Access Compliance Report

Public Rights-of-Way

(Curb Ramps)

Intersection ID: 10020719	Main Street: BEATTIES_FORD_RD	Cross Street: N/A	Location: W
ADA ID: BE3D3688E09C	Ramp Type: Perp	Initial Pass/Fail: Fail	Overall Compliance: No
Severity Score: 12.5			
Codes/Mitigation Info/Possible Solution		Field Measurements/Component Compliance

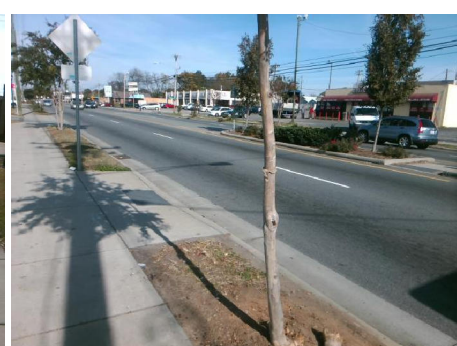
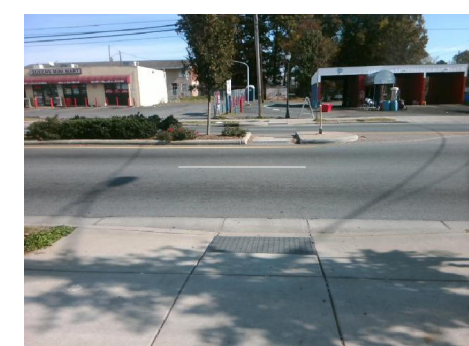
Possible Solutions:						
	Remove & Replace Entire Ramp.	N/A	Ramp Length (in)	48.0	No	Ramp Slope (%)	10.9
		Yes	Ramp Width (in)	48.0	Yes	Ramp XSlope (%)	0.1
		N/A	Flare Type LT	N/A	N/A	Flare Type RT	N/A
		N/A	Flare Slope LT (%)	N/A	N/A	Flare Slope RT (%)	N/A
		N/A	Flare Traversable LT?	N/A	N/A	Flare Traversable RT?	N/A
		N/A	Landing Length (in)	N/A	N/A	DWS Provided?	N/A
		N/A	Landing Width (in)	N/A	N/A	DWS Contrast?	N/A
		N/A	Landing Slope (%)	N/A	N/A	DWS Length (in)	N/A
		N/A	Landing X Slope (%)	N/A	N/A	DWS Full Width?	N/A
		N/A	Landing Curb? (Y/N)	N/A	N/A	DWS Offset (in)	N/A
		N/A	Shared Landing?	N/A			
		N/A	Gutter Ponding?	N/A	N/A	Gutter Slope (%)	N/A
		N/A	Gutter Lip Ht (in)	N/A	N/A	Gutter X Slope (%)	N/A
		N/A	Painted X Walk1?	No	N/A	Painted X Walk2?	N/A
			X Walk 1 Direction	To E		X Walk 2 Direction	N/A
		N/A	X Walk 1 Width (in)	N/A	N/A	X Walk 2 Width (in)	N/A
			X Walk 1 Slope (%)	3.0		X Walk 2 Slope (%)	N/A

X Walk 1 X Slope (%)	0.6		X Walk 2 X Slope (%)	N/A
		N/A	Ramp inside XWalk1?	N/A	N/A	Ramp inside XWalk2?	N/A
<p>Surveyor Notes:</p> <p>N/A</p> <p>PROW/ADA:</p> <p>Not Found, R304.2.2</p>			Road Slope (%)	N/A	N/A	Clear Space?	N/A
			Road X Slope (%)	N/A	N/A	Clear Space to XWalk (in)	N/A
		N/A	Any Obstructions?	N/A	N/A	Storm Grate/Utility Hazard?	N/A
			Obstruction Type			Storm Grate/Utility Type	
					N/A		N/A
					Yes	Surface Condition? (G/P)	Good
